# Within CHAMPAGNE AND AISHIHIK TRADITIONAL TERRITORY

### FOREST MANAGEMENT BRANCH ENERGY MINES AND RESOURCES YUKON GOVERNMENT

PREPARED: June 7, 2011

Map 1. Comments submitted by CAFN for Operating Units MC02 of the Marshall Creek THP

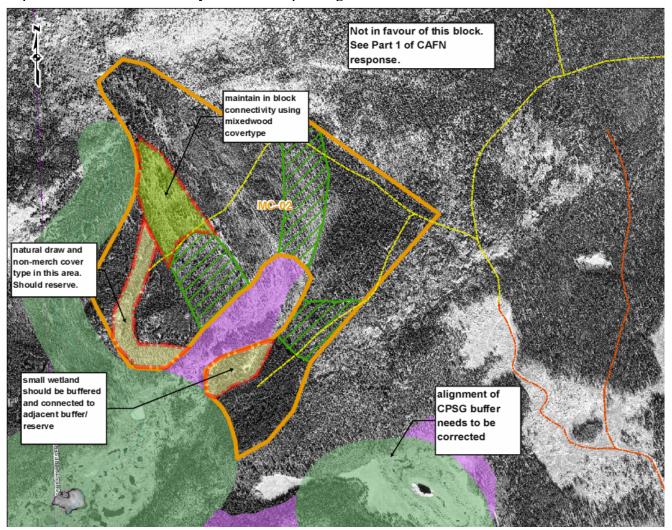
5.0Access Management				populations.
6.0Timber Harvest Project Referral and Approval Process				
CAFN comments specifically for operating unit MC2, MC3 & MC4	CAFN	See Maps 1,2,3 Below	Operating units will be further designed into blocks at the cutting permit phase. The cut block design will be consistent with this THP and all upper level plans and will take into consideration operation requirements of the licencee.	Recommendatio ns specific to cut block design will be considered at the cutting permit phase.
